RECEIPT DATE: 3-10-22 **ONSITE SEWAGE DISPOSAL SYSTEM** P 570992

PROPERTY ADDRESS: 5513 Jacks Landing Way Clarksville

SUBDIVISION: Jacks Landing, Phase II LOT: 7 TAX ID: \_\_\_\_\_

**RE:** OSDS Plan  
Jacks Landing Phase II, Lot 7  
5513 Jacks Landing Way

3/29/2023 - incorrect install of D-box (SP)

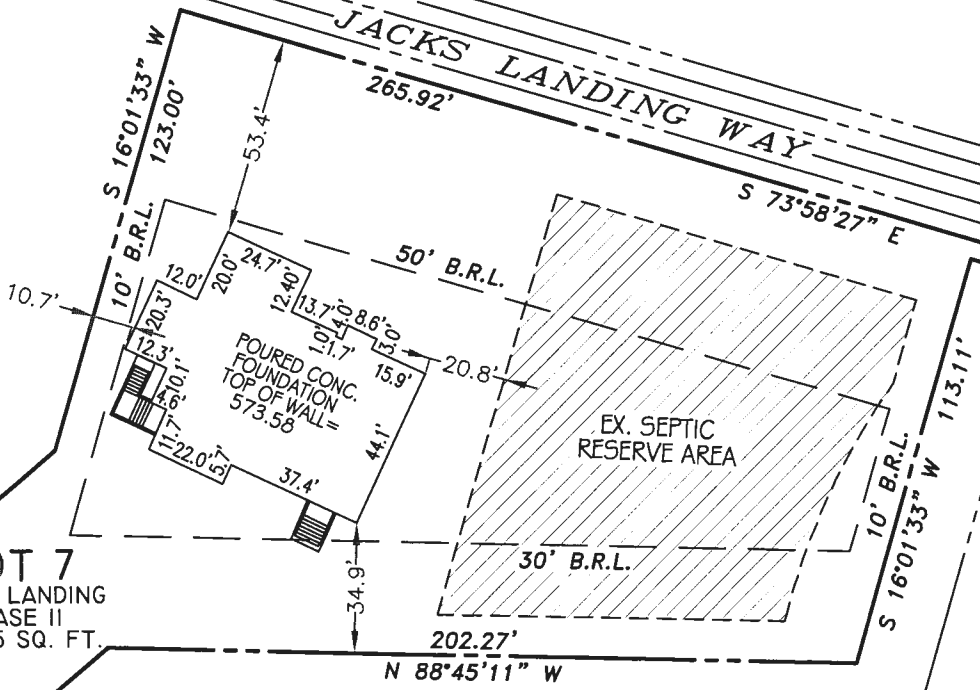
3/29/2023 - Inspected D box to water treatment trenches, D box set according to plan, which will be incorrect. Each trench should have its own connection to D box. Told installer to reposition & call for reinspection. (SP)

3/30/2023 - D-box plumbing to feed into each trench individually. Installer did not hire render or sift. ROAD NAME reinspect for both during water level

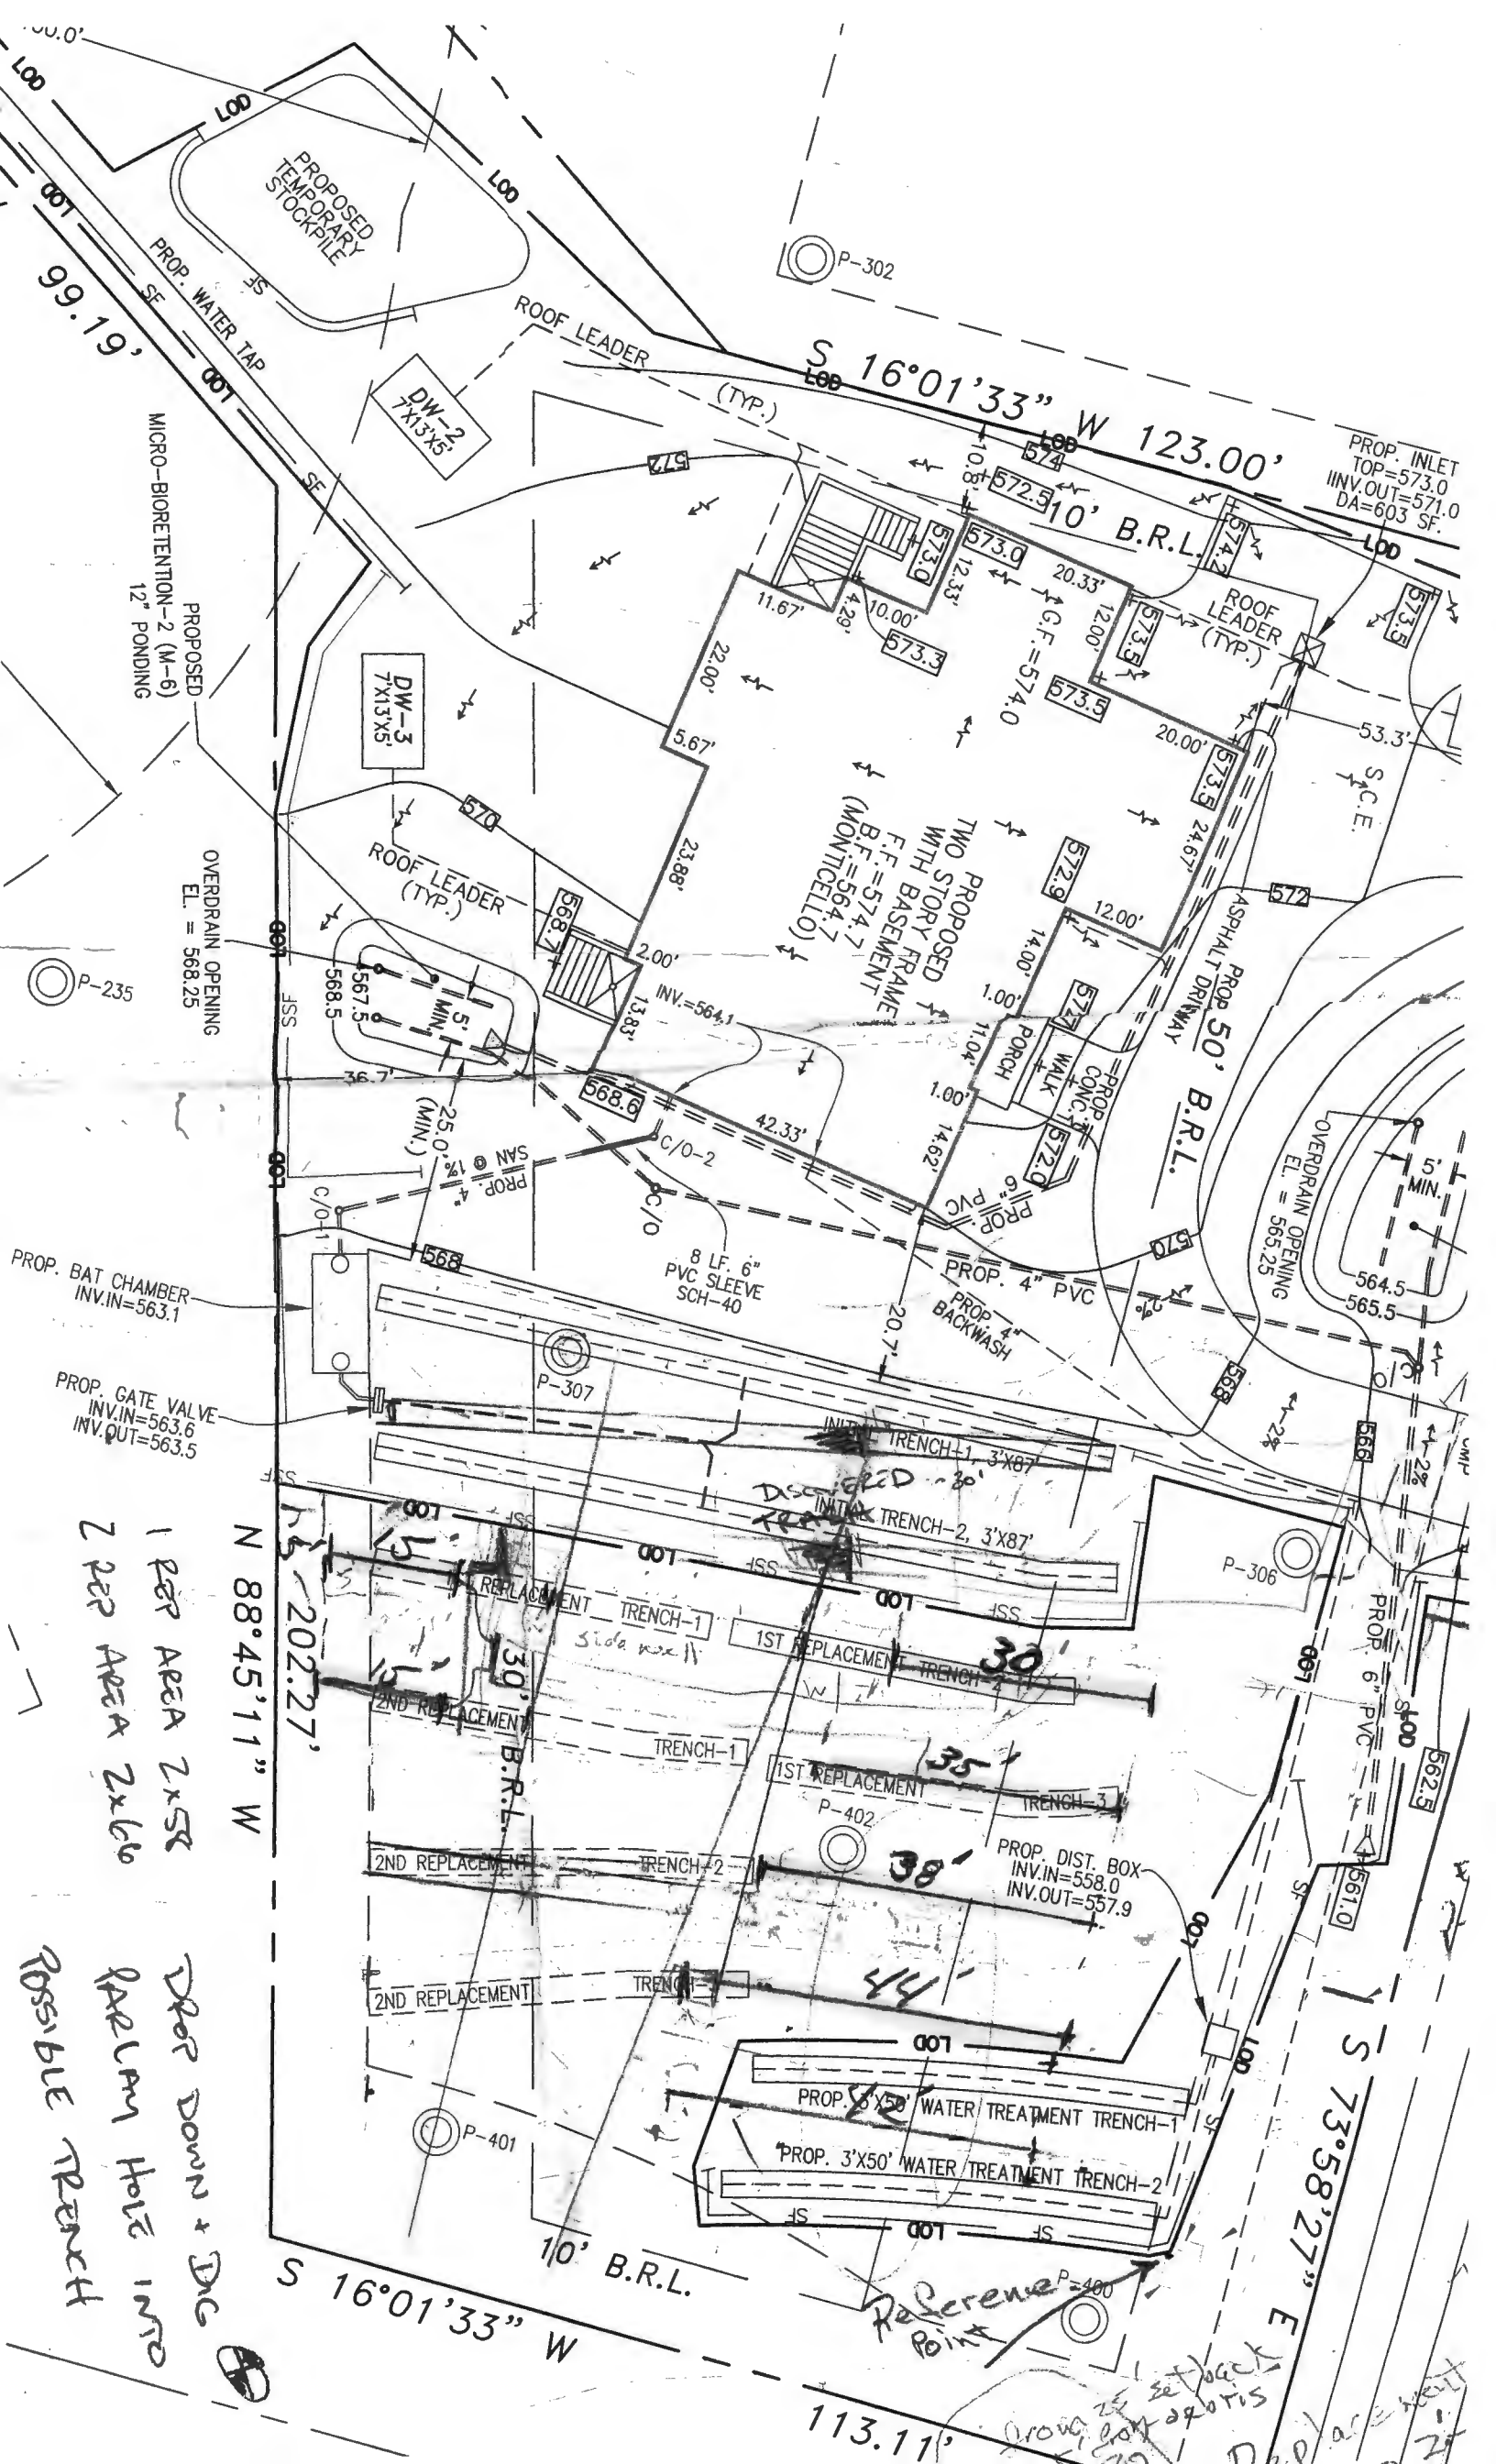
Thanks Chris. According to the wall check, the sewer invert out of house should be approximately 9.48 feet below the top of wall elevation. The grade over the BAT tank at the inlet should be roughly 3.14 feet. This certainly did not look like we were going to have 3.14 feet of cover over the BAT tank. Something has changed in the field based on the wallcheck and approved osds plan, they don't line up. The max cover on tanks is 3 feet. Carl/NJ you will need to
